OBJECTION: 916 Union Street Cell Antenna Project
Adrienne Lakadat - 900 Union Street – adjacent neighbor
To: Planning Division planning@alamedaca.gov

OBJECTION: 916 Union Street Cell Antenna Project
Letter #2

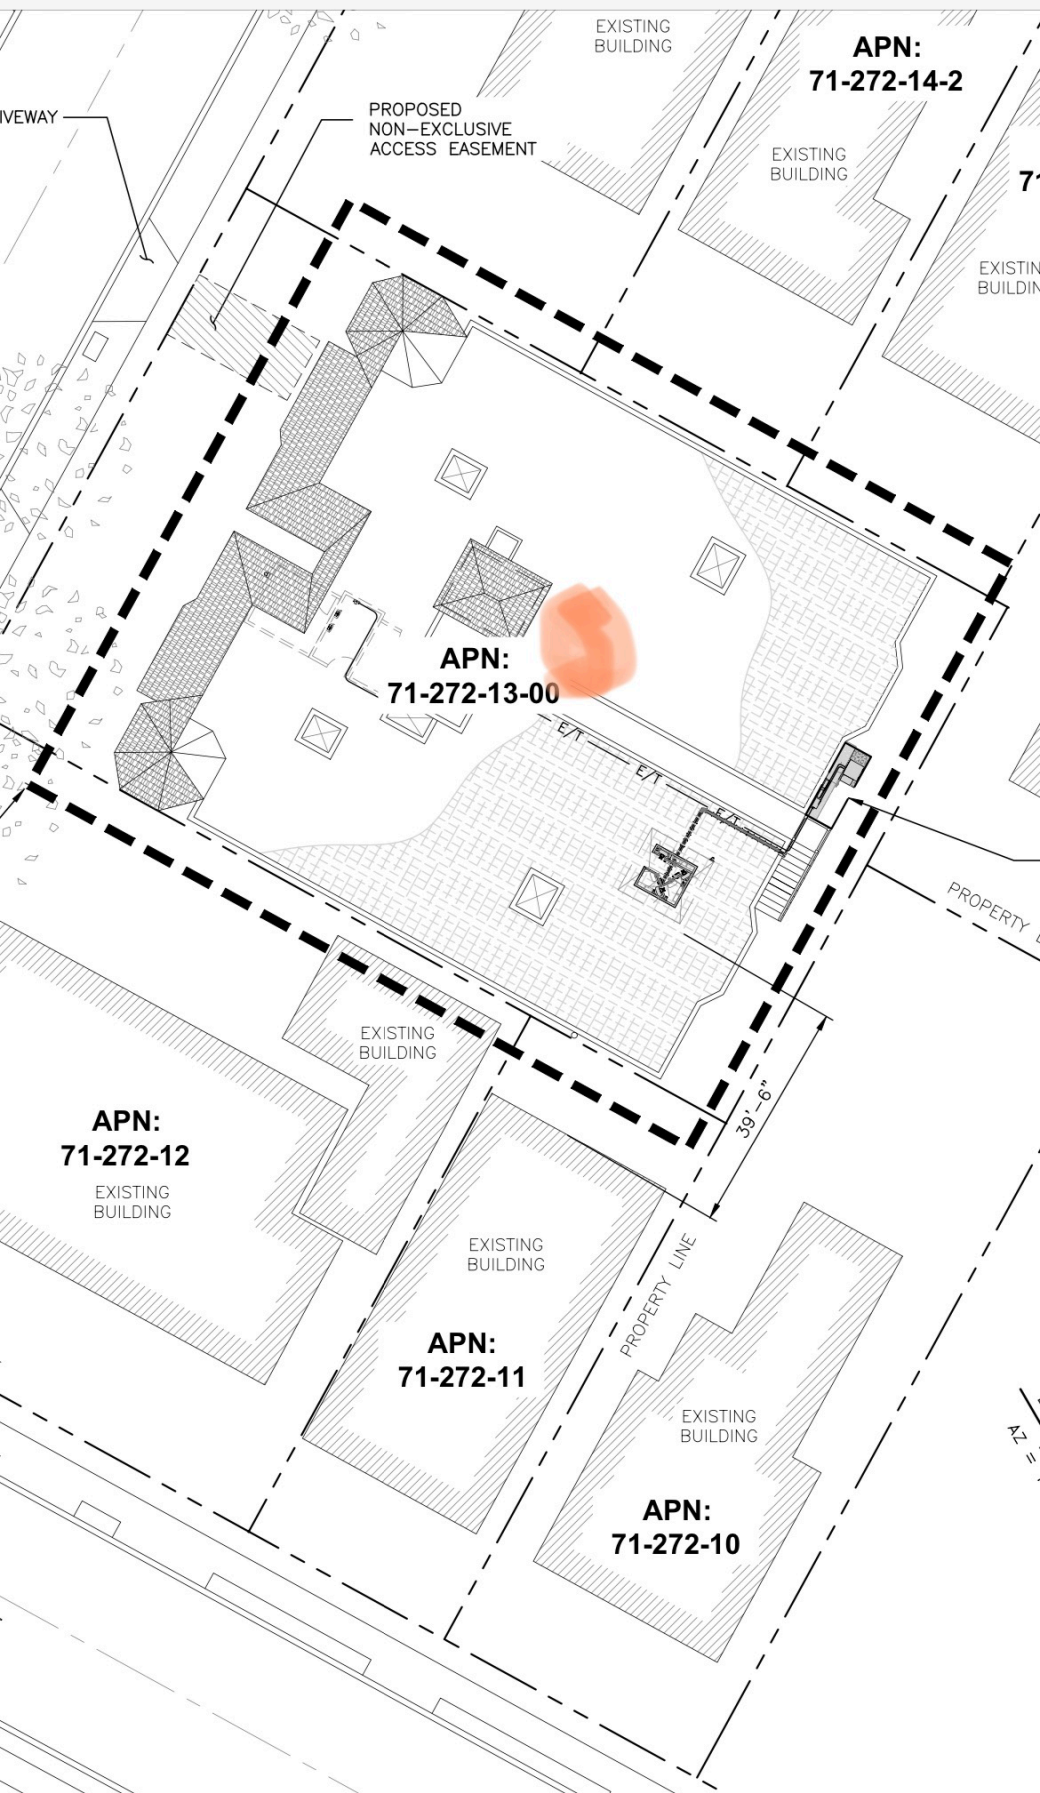
1. Part of our living space in existing building AP 71-272-11 has been omitted from drawing A-1. This is a serious cartographic omission. We have a permitted living space in the form of a detached garage abutting the property line. It is a home office that I spend 8-10 hours a day in, and this falls squarely within the 39'6" distance marker indicated on the diagram, which is intended to convey the distance from the facility to our home. We estimate the distance between the proposed facility and the edge of our home to be about 19'6", which is within the acknowledged "danger zone".

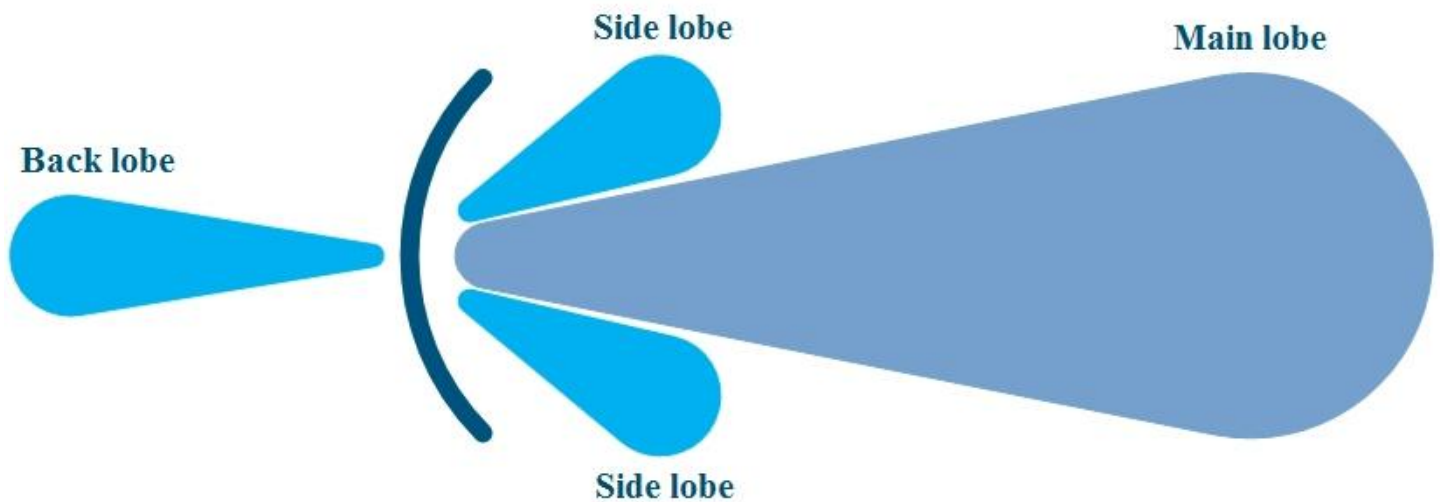
I have read some of the project documents that are available online as well as some of the documents from neighbors of the apartment house and I feel that something is not right with this plan.

The safety of the people living in the area surrounding the proposed location of three new structures on the roof of the apartment at 916 Union Street has not been properly addressed.
